MEMORANDUM

RE: **Appeal of Denial of Vacation of Non-Access Easement (12VE013) to allow two approaches on Elk Vale Road to be utilized for ingress and egress to a commercial property.**
Tract 3 less Lot 1, Discovery Subdivision, Section 28, T2N, R8E, BHM, Rapid City, Pennington County, South Dakota.

ELK VALE ACCESS
SITE PLAN
TRACT 3 LESS LOT 1, DISCOVERY SUBDIVSION
RAPID CITY, SOUTH DAKOTA
NOVEMBER 9, 2012

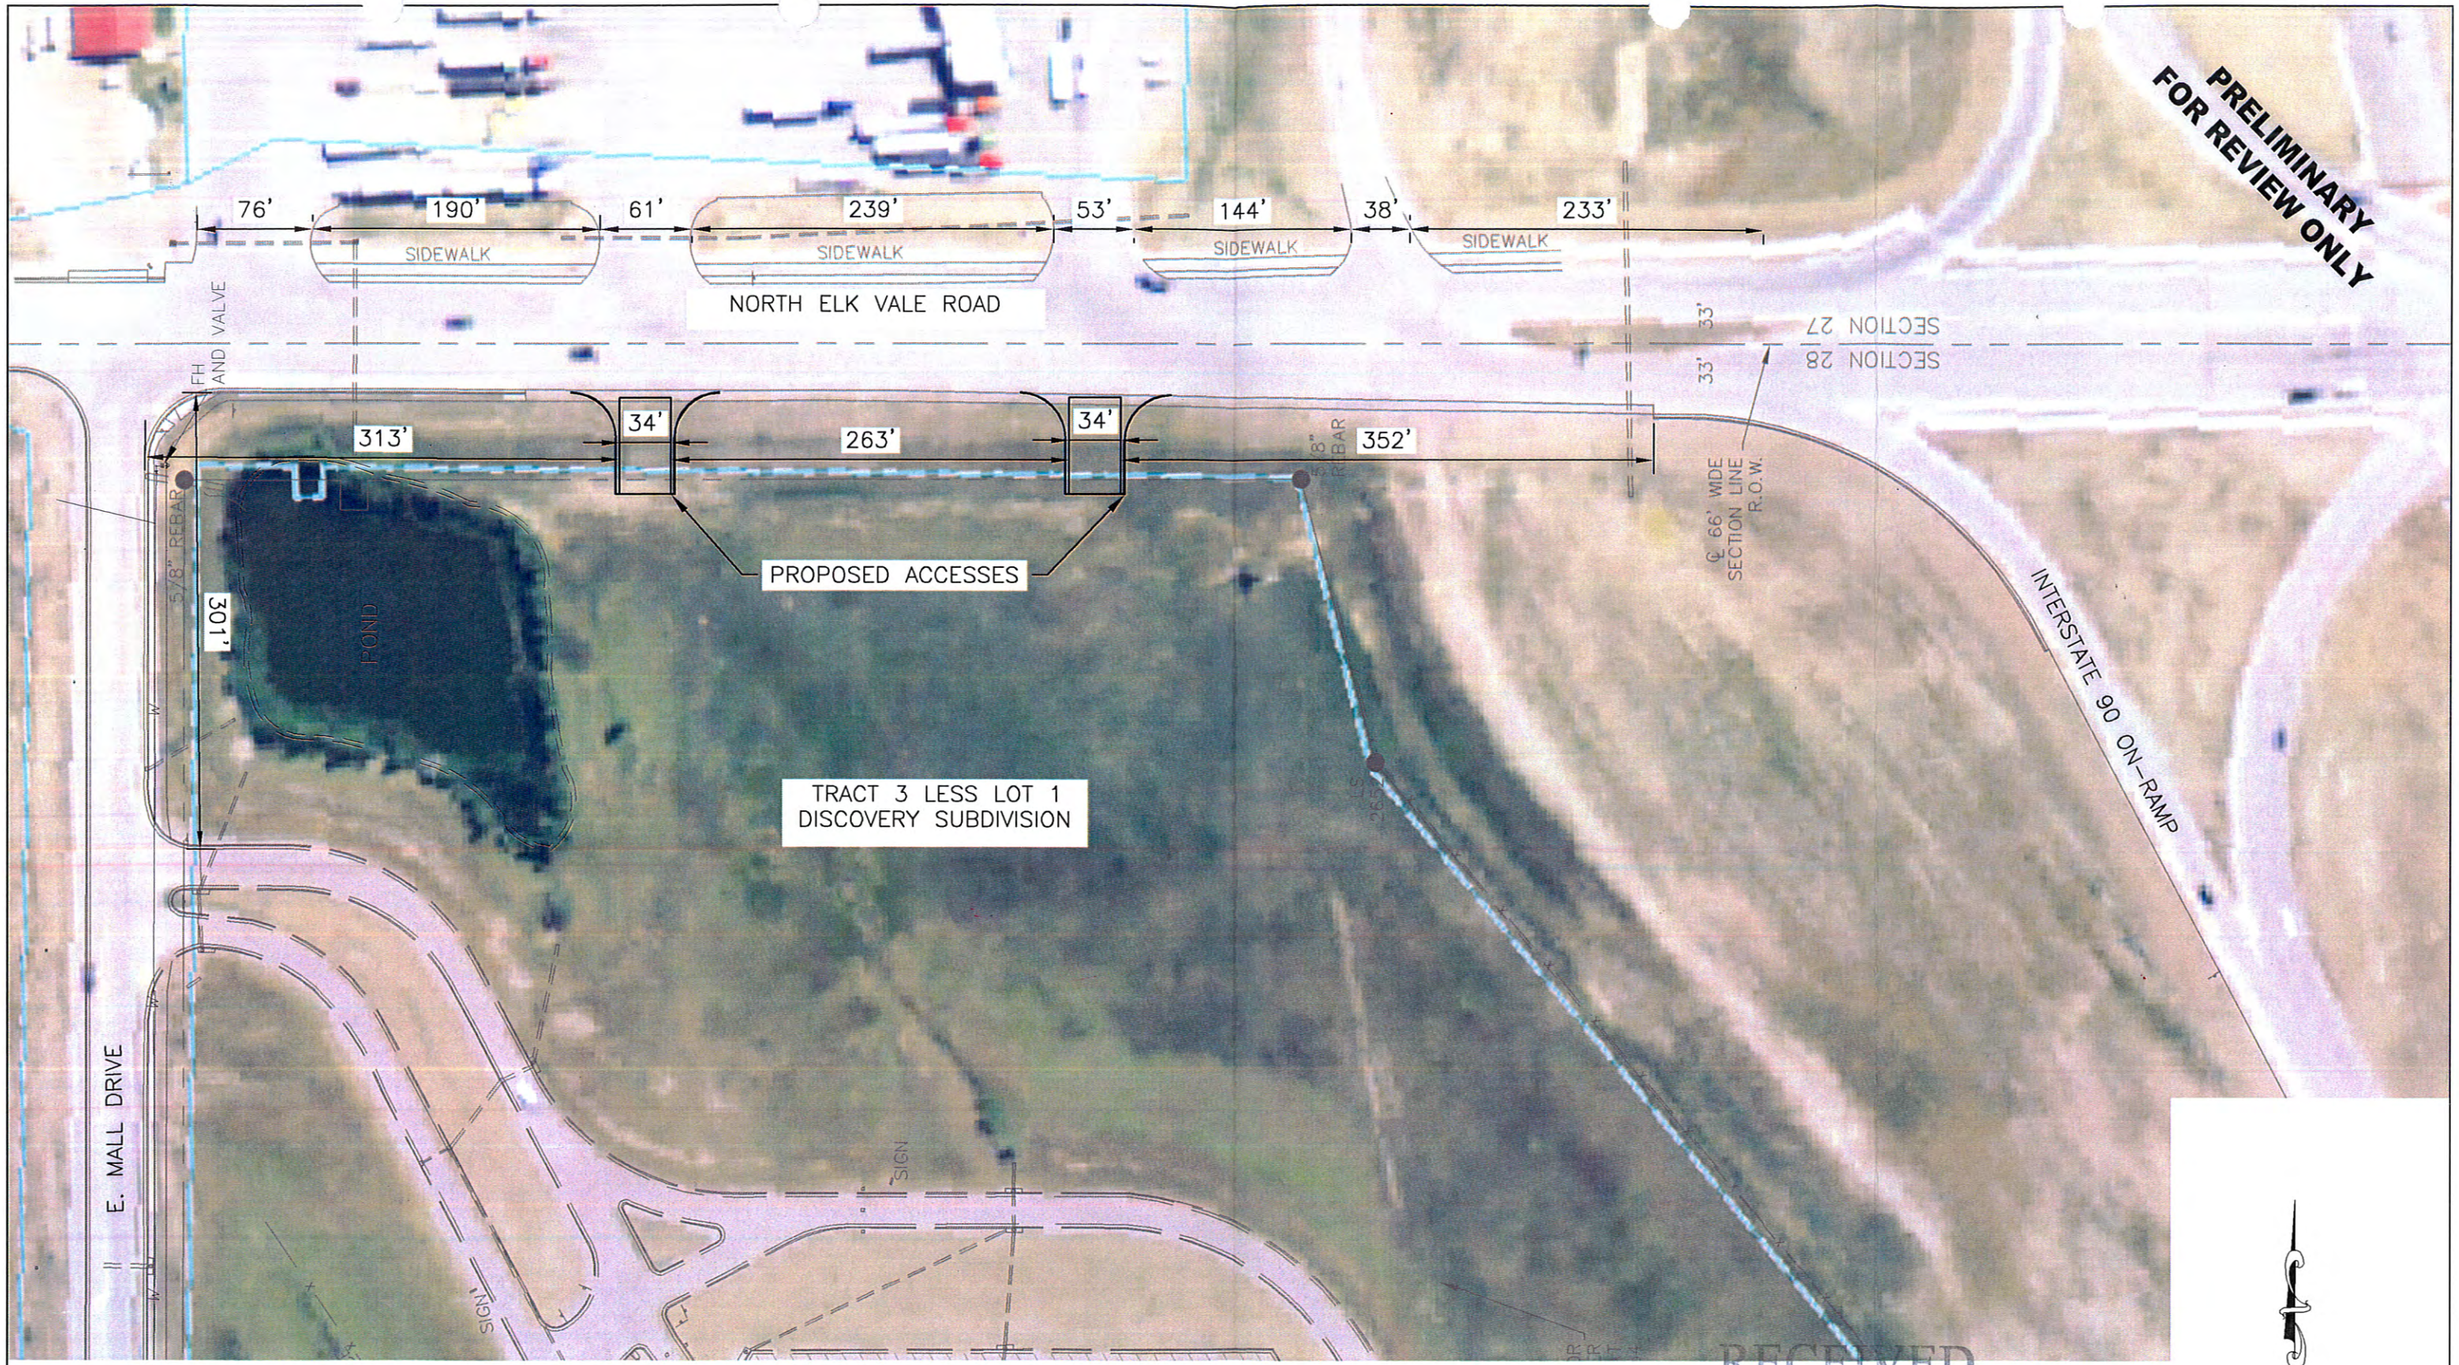
During Layout Plan review (12PL049 – August 2012) for a proposed subdivision, the applicant proposed two (2) approaches along the west side of Elk Vale Road north of Interstate 90 and south of East Mall Drive (see attached plan). South Dakota Department of Transportation (SDDOT) indicated that they control the access approaches between Interstate 90 and East Mall Drive. The SDDOT stated that they would allow one access approach approximately 650 feet north of the interstate 90 ramp intersection in accordance with their approach spacing criteria. On November 2, 2012, the state recognized upon further examination that they in fact do not regulate the access approaches in this location and that the City would be the jurisdiction to approve or deny any proposed access points.

SUMMARY: Given that the City and SDDOT can make recommendations to each other in situations where their jurisdictions overlap, and one of the agencies may have more stringent criteria for their facilities, the application for vacation of non-access easement was denied due to lack of adequate spacing from interstate 90 per SDDOT's Access Location Criteria.

Staff Recommendation: Although the City's IDCM does not provide specific guidelines for access spacing in the vicinity of an interstate interchange, the SDDOT guidelines do. Therefore we feel it is appropriate to rely on their recommendation. Staff recommends denial of the appeal in order to not allow the vacation of non-access easement for an approach less than the SDDOT recommended 650 feet from an interstate ramp intersection.

The City may be able to support the northerly access approach once a Preliminary Subdivision Plan has been approved illustrating the number of lots which will gain access to Elk Vale Road using the approach. A Traffic Impact Study is already required for subdivision of the property, and it should include analysis of any access points onto Elk Vale Road. City staff also has concerns with the large grade difference between the proposed site and Elk Vale Road. Any access allowed onto Elk Vale Road shall be analyzed for vertical sight distance.
